July 12, 2012

**Re: Storm Water Inspection at Wendy's Company Office Building & Conference  
Center- Franklin County  
Permit # 4GC03807\*AG**

Figure 3 Barren Areas

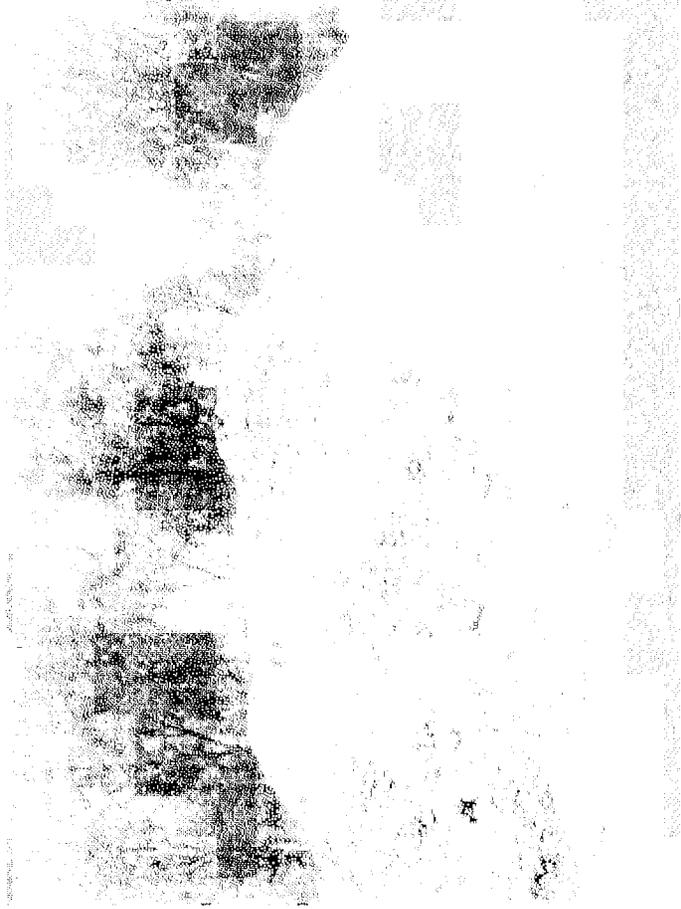
- The sediment controls implemented on west side of this site will require maintenance or reinstallation to ensure a proper functioning condition (See Figure 1).
- Our staff observed an area of concrete disposal that lacked proper containment. If future onsite disposal is required, containment measures such as a pit impoundment is expected (See Figure 2).
- Be aware the General Permit states that all barren areas which remain idle in excess of 21 days must be protected from erosion within seven days of the last earth disturbing activities. In addition, erosion protection must be implemented for all areas of final grade within seven (7) days (See Figure 3).
